REPORT AMENDED BY STAFF 3-4-87
CIT PLANNING COMMISSION

APPLICATION: A. Plan Review of a 2,920 sq. ft., 74 seat fast-food restaurant with one drive-through window on 0.9+ acres in the General Commercial-Review (C-2-R) Zone

PROPOSAL: The applicant is requesting the necessary entitlements to construct a Kentucky Fried Chicken fast-food restaurant with a drive-through window

Subject: Special permit to develop a 2,920 sq. ft. restaurant with one drive-up window
(P87-039)

SITE PLAN

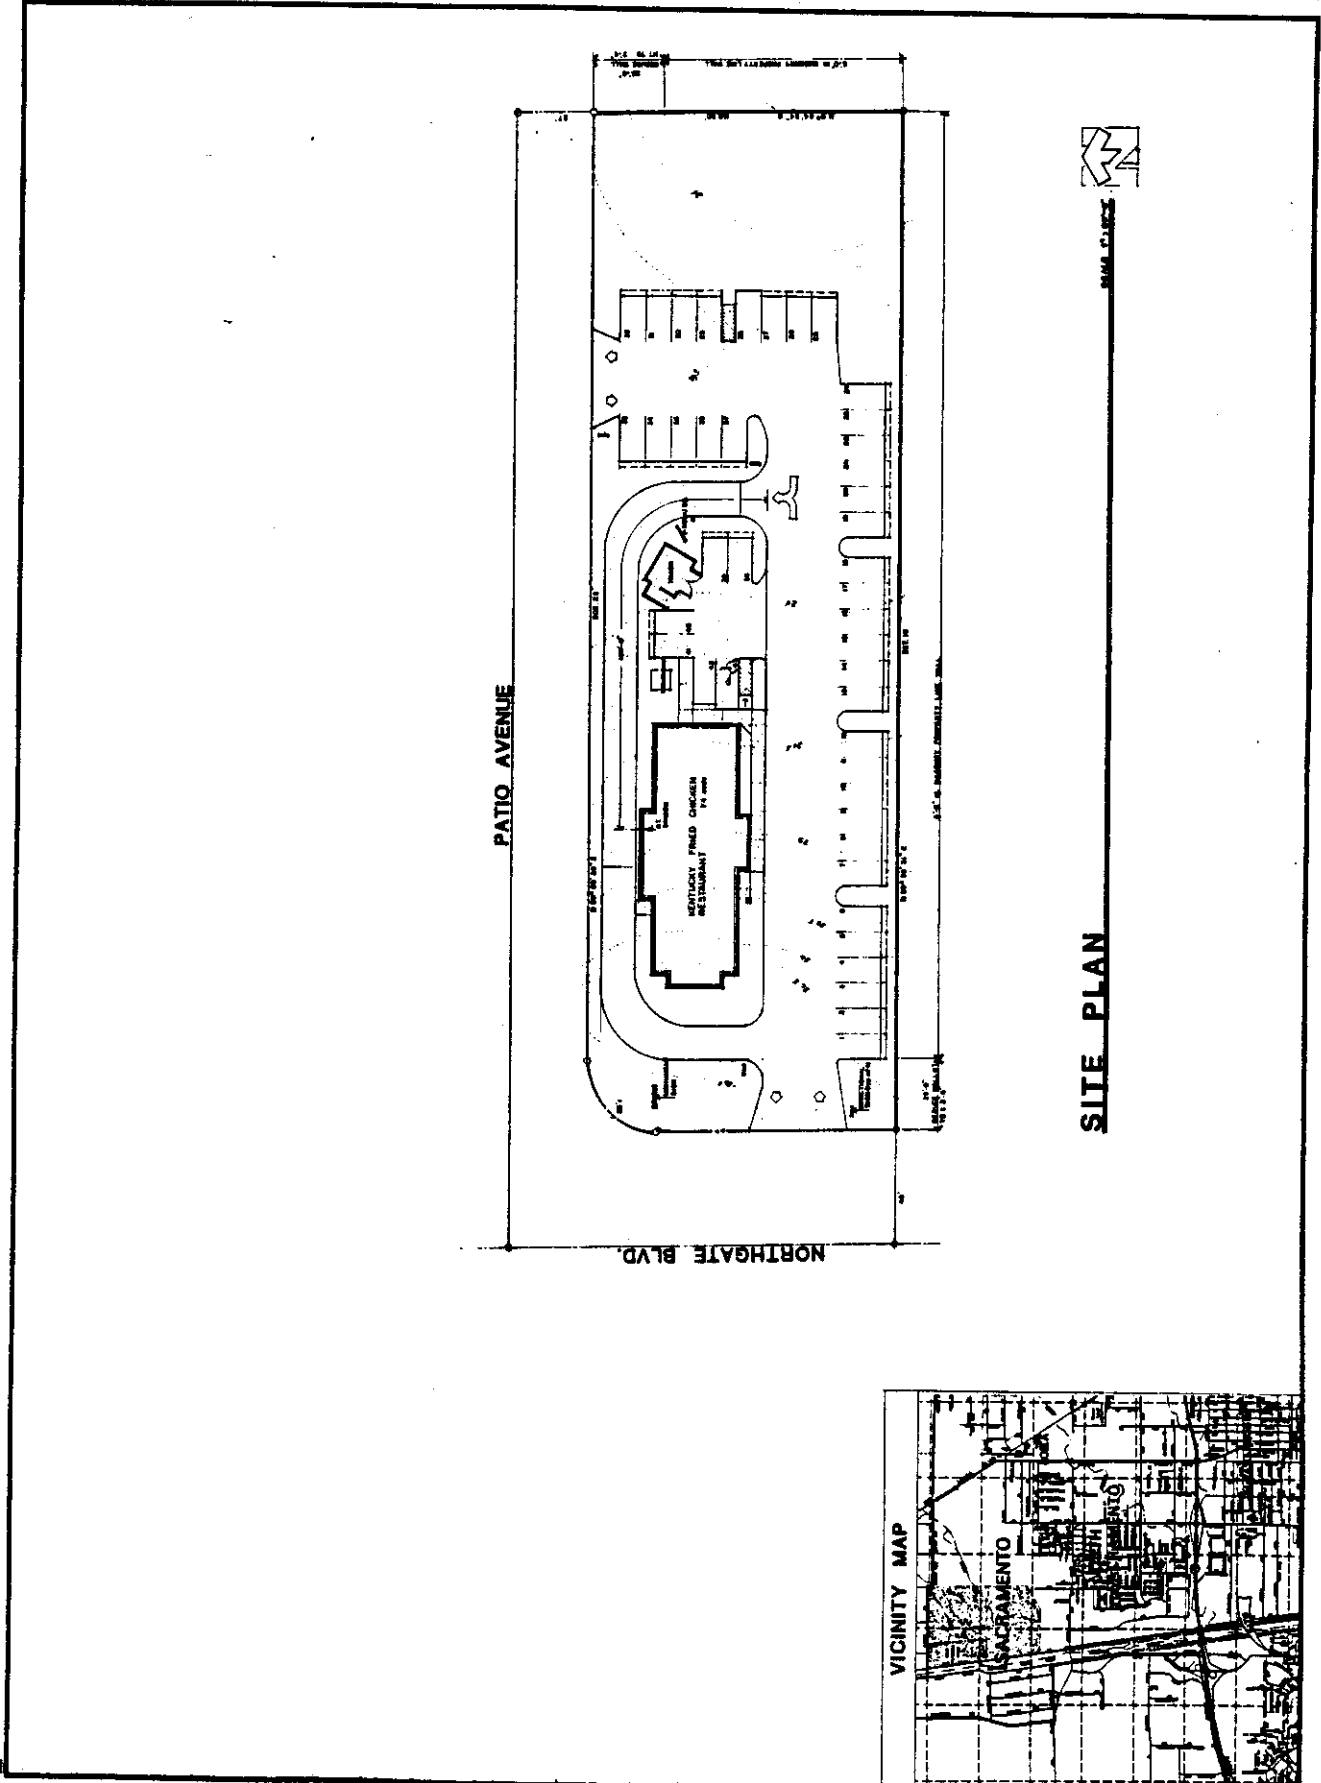
2. **Trash Enclosure:** The applicant's site plans show a trash enclosure. Staff recommends that the trash enclosure comply with the attached Trash Enclosure Guidelines (Exhibit A).

3. **Walls:** A 6-foot high solid wall is shown along the south and east property line. The method of construction and type of wall appears to be masonry block on a concrete foundation. Staff recommends that the wall be constructed of a decorative material and color compatible with the restaurant's design. The wall shall observe the height limits within the 25-foot setback area off Northgate Boulevard and Patio Avenue.

4. **Driveway for Drive-Through Window:** Staff has discussed with the applicant a potential conflict with pedestrian traffic coming off Patio Drive across the drive-through driveway to the north door. The office/warehouse development and future use by Golden Gate University to the north of Patio Avenue may create an increase in pedestrian traffic across the drive-through driveway. Staff recommends that the applicant revise his site plan to provide intensive landscaping along Patio Avenue in the 5-foot planter adjacent to the sidewalk to deter through traffic. Another alternative is to provide a walkway with railing to prevent access adjacent to the north side of the building leading from the Northgate Boulevard.

5. **Utility Transformer and Meters:** Staff recommends that any utility distribution facilities be screened so to not be visible off-site. The SMUD transformer proposed between the building and trash enclosure shall be screened with materials or landscaping compatible with the building.

City Code requires one Class I bicycle parking facility for each 25 required parking spaces for commercial uses. The applicant is required to provide 28 spaces and shows 43 including one handicapped. The revised site plan shall show the location of a bicycle storage facility.

Exterior parking lot lighting is proposed on poles. Staff recommends that all exterior parking lighting and building lighting be directed on-site and not reflect off-site onto residentially zoned or used lots. Use of light shields are recommended.

1. Increased landscape strip along the south property line to 6 1/2 feet. These may require redesigning stalls 1 to 12 to a 60 degree angle.
2. Eliminate the 2 stalls, number 32 and 33 closest to Patio Avenue at the driveway so no vehicles back into traffic entering or exiting the site. The total area free of parking should be 20-foot deep as measured from the Patio Avenue right-of-way property line. Staff recommends landscaping in the area which does not create a visibility problem.
3. The revised site plan shall show all dimensions of driveways, parking spaces, building setbacks and landscaped areas. Due to the limited area of the site, dimensions are necessary to determine viability of the site layout.

2. Six-foot high decorative walls shall be shown on a revised site plan adjacent to residential zones compatible in color with the restaurant.
3. All driveways shall be designed to City standards for commercial driveways. All improvements to the public right-of-way shall be reviewed and approved by the City Engineer's Office.

4. The trash enclosure shall be designed according to the attached trash enclosure guidelines (Exhibit A).
5. The applicant shall restrict access off Patio Avenue across the drive-through driveway by use of intensive landscaping or providing railing or barrier along the north building elevation opposite the north doorway. An "Exit Only" doorway may be most appropriate with no external door hardware.

6. The eastern portion of the lot shall be landscaped with grass, irrigated and maintained in a litter free condition.
7. The parking lot shall delete stalls 32 and 33 closest to Patio Avenue so that a minimum of 20 feet of vehicle clear area is established off Patio Avenue. Landscaping shall be low profile so to not provide visibility problems.

11. Utility meters and transformers shall be screened from roadway view.
12. Bicycle parking shall be provided as per the City Parking Ordinance.
13. A uniform signage program shall be submitted for review and approval by the Staff prior to issuance of sign permits. The monument sign shall not exceed 6 feet in height as measured from top of sidewalk.

LANDSCAPE PLAN

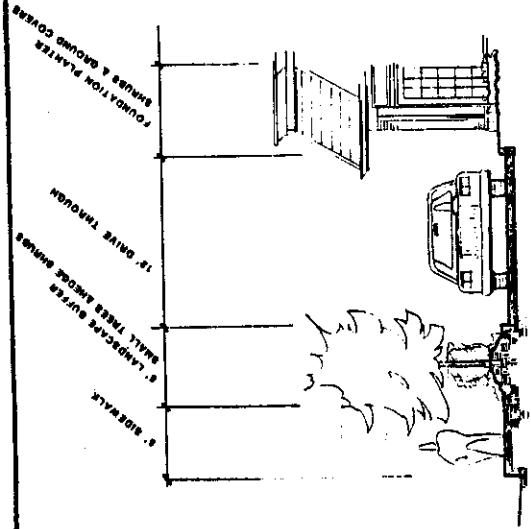
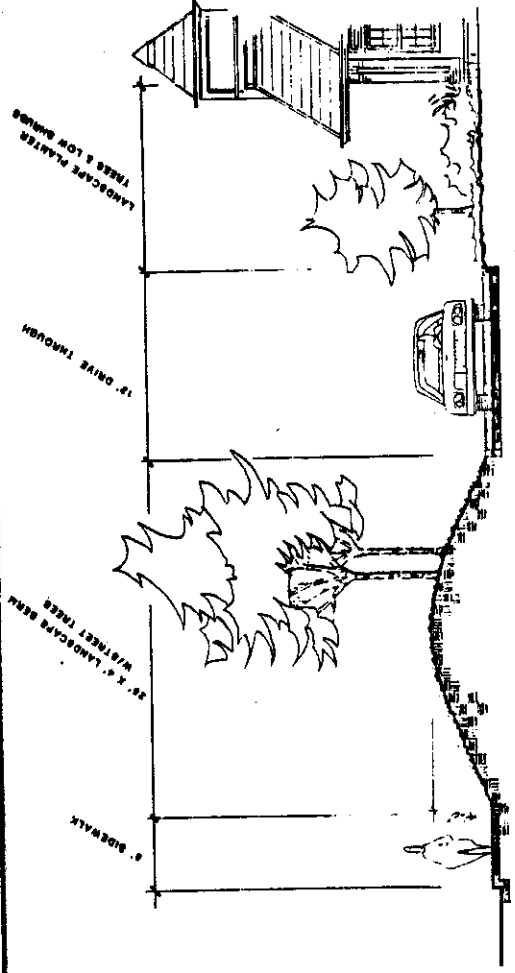
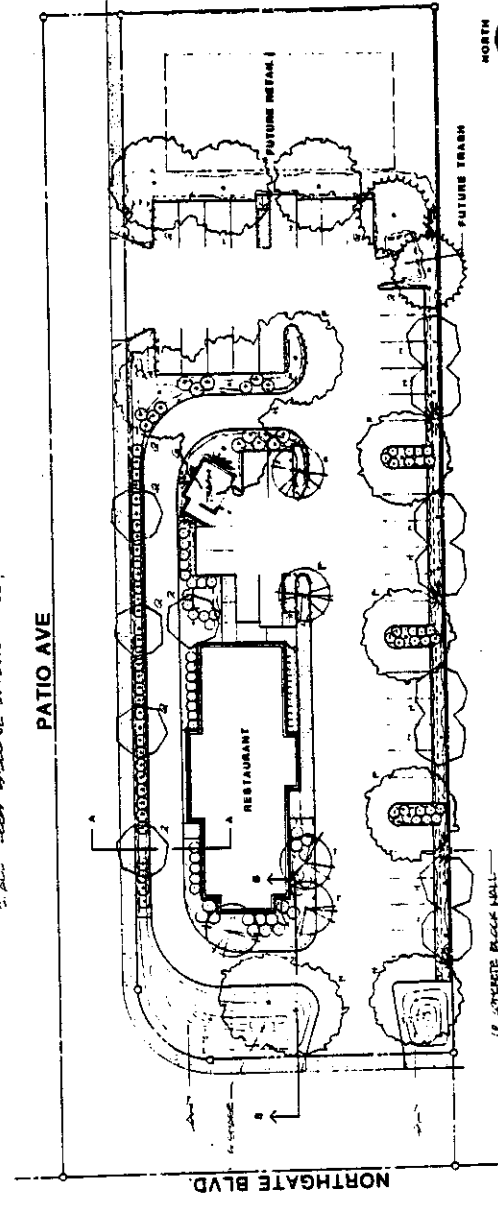
1. **South Property Line Wall:** Staff notes that deciduous trees are shown along the landscape area adjacent to the south property line. Staff recommends use of evergreen trees for shading adjacent to the residentially zoned property in place of the deciduous trees. It should be noted the landscape planter adjacent to the south property line will require an increase in width from 5 feet to 6 1/2 feet allowing 6 inches for a wall, 2 feet for vehicle overhang and 4 feet of clear, unobstructed landscaping between the wall face and vehicle overhang area.

2. **Trees Shading Requirement:** The applicant's preliminary landscape plan appears to meet the 50 percent shading coverage requirement. The applicant shall maintain the coverage when selecting evergreen trees along the south property line landscape strip.

3. **Curb and Wheel Stops:** The applicant shows the use of 6 inch concrete curb with vehicle overhang. Staff recommends that no portable concrete wheel stop be used on the site and that 6-inch concrete curb be used adjacent to all landscape areas.

4. **Bark Mulch:** Groundcover under shrubbery on the landscape plan is not clearly identified. Staff notes that within the landscape street frontages, living groundcover is required. Staff recommends that all exposed areas be planted with living groundcover with no use of bark, mulch or rock.

5. Future Retail Area: The applicant's landscape plan shows the eastern portion of the lot as a possible retail store site. Until the area is developed, staff recommends that the area be landscaped with grass, irrigated during the summer and maintained in a weed- and litter-free condition. Fencing off the area may be appropriate if loitering or security problems arise. Staff recommends the revised landscape plan show the type of groundcover. Irrigation plans can show use of a hose bib to service the area unless automatic irrigation is desired by the applicant. The applicant indicated the use of a rye grass with high mowing and weekly watering during the summer months as an option. Specifics remain to be worked out between the owner and applicant.

1. Revised landscaping, shading, and irrigation plans for the site shall be submitted for Staff review and approval prior to issuance of building permits.

8. Parking lot shall comply with the 50 percent shading requirement. A minimum 4-foot planter strip and 2 additional feet of planter for vehicle overhang shall be provided adjacent to the wall.

9. No bark mulch is to be used on the site. Living groundcover is required under shrubbery on the revised landscape plans.
10. Landscaping shall be designed to comply with minimum visibility requirements for all driveways and intersections.

15. No prefabricated wheel stops shall be used on the site. All wheel stops shall be six-inch high continuous-pour concrete which incorporates a two-foot vehicle overhang into the landscape area.

ENTER/EXIT SIGNS

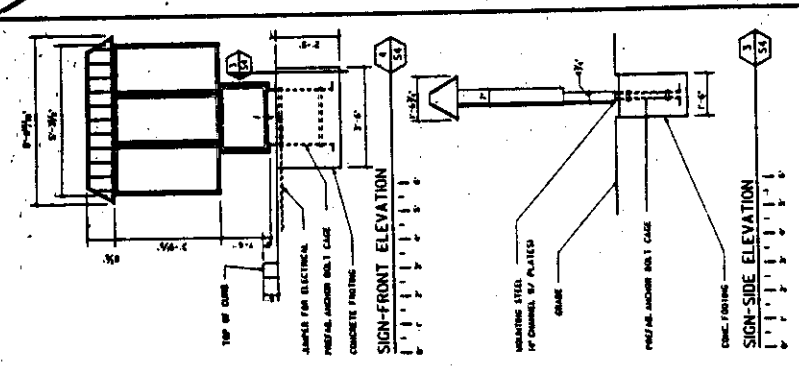
3. Welcome/Enter Sign: The sign showing the logo and words "Welcome/Enter" should be downsized from 5-feet high, 3 1/2-foot wide size to a more modest size of no greater than 4-square feet of sign area and 4 feet in height. The signs should be set back more than 10 feet from the public right-of-way. The words "Welcome/Thank You" and the logo are not allowed as part of the directional sign. Staff recommends that the applicant submit a signage program reflecting all above concerns for review and approval by the Planning Director prior to issuance of sign permits.

DRIVE-THRU MENU BOARD

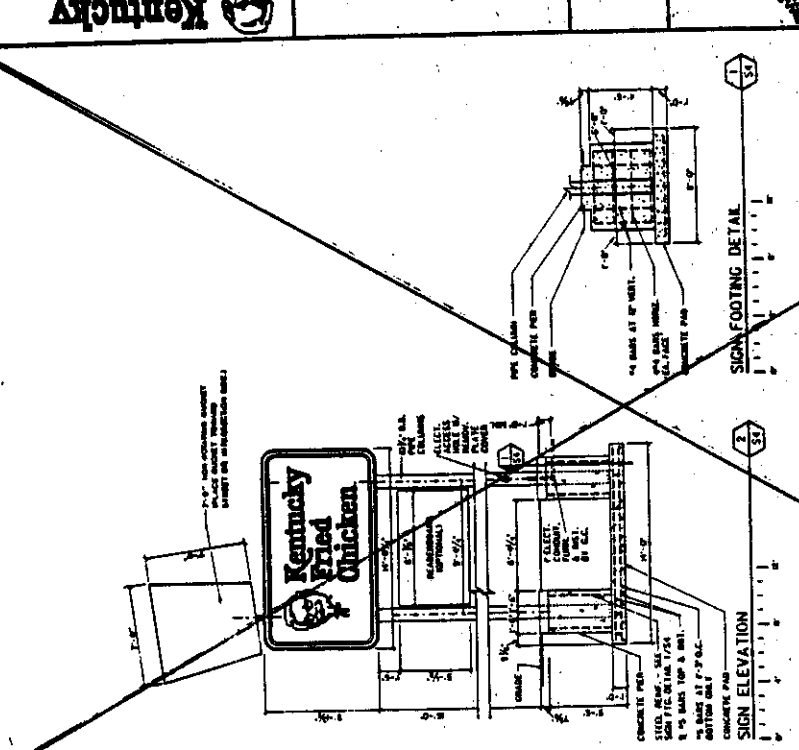
The drive-through window requires an external speaker unit. Staff recommends that the volume on the loudspeaker be controlled so to not be audible to adjacent residentially zoned property. The menu board may required readjustment to face northward so that the loudspeaker projects to the north and not east as shown.

16. The one way only drive-through exit shall be clearly marked so the public does not mistake the driveway for an entrance. The sign shall be approved by the Planning Director as part of the sign program.
17. The loudspeaker used by the drive-up window shall not be audible to adjacent residential windows.
18. The revised site plan shall show all dimensions.
19. The existing single-family dwelling shall be offered for relocation 60 days prior to demolition. Trees shall be retained if possible on the landscape plan.
